HARVEY CHEN

A PORTION OF THE NW 1/4 OF THE NW 1/4 OF SEC. 19, T 24 N., R 05 E., W.M.
KING COUNTY, STATE OF WASHINGTON

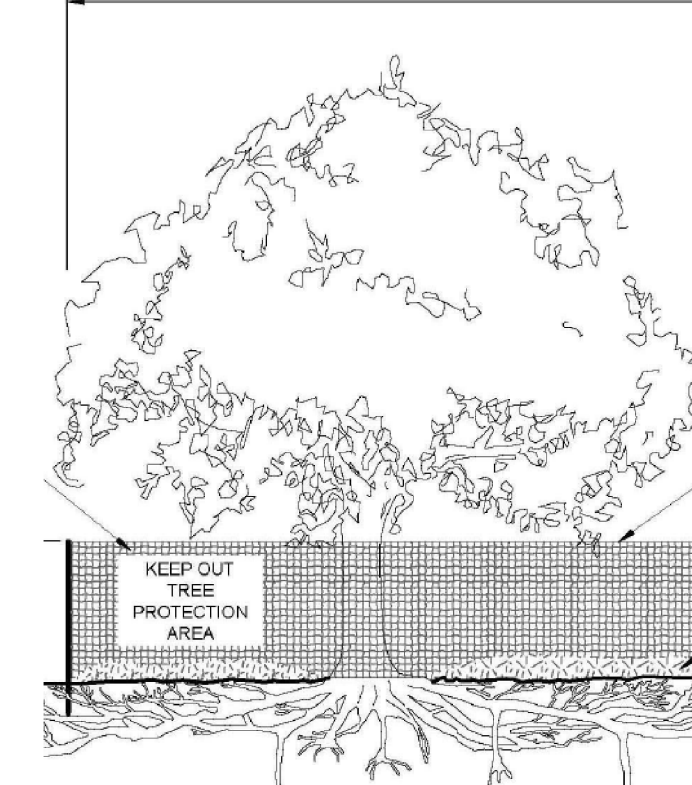
1. Correction Notices or Stop Work Orders until compliance is achieved
2. RE Inspection Fees/financial penalties
3. Arborist reports recommending mitigation

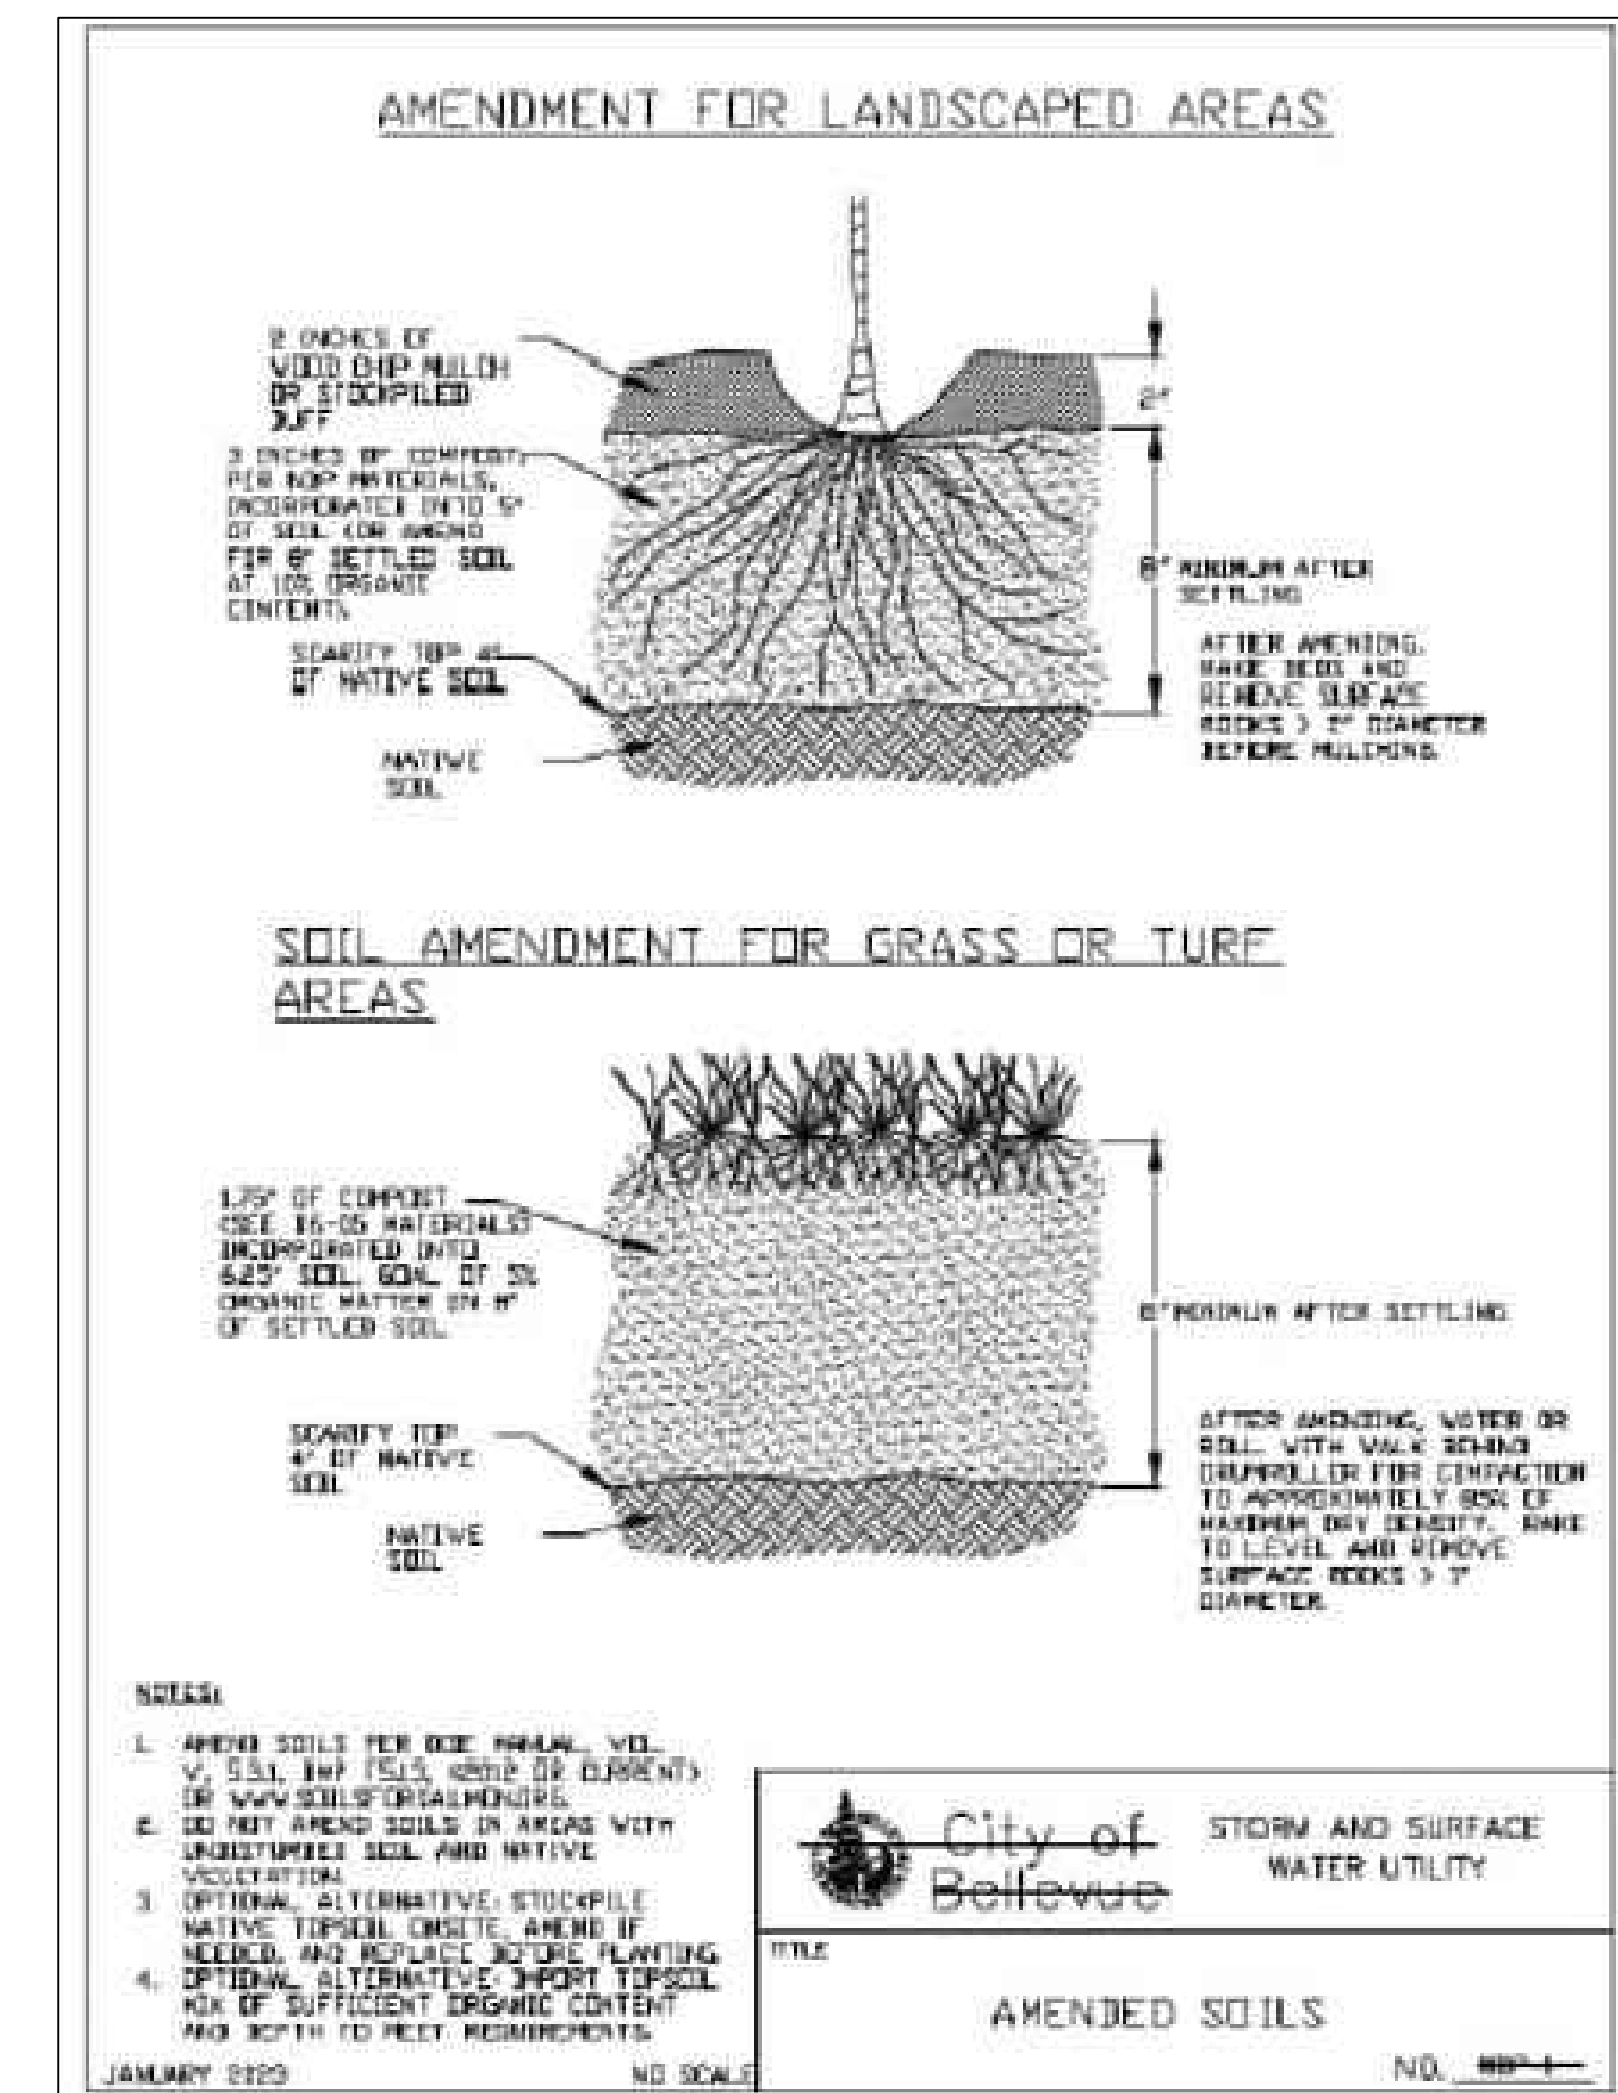
Checked: 12-28-23 PRELIMINARY PLAN
1. 4-26-24 REVISED TO ADD TREES AND SOIL REQUIREMENTS
Drawn: REB
GCA
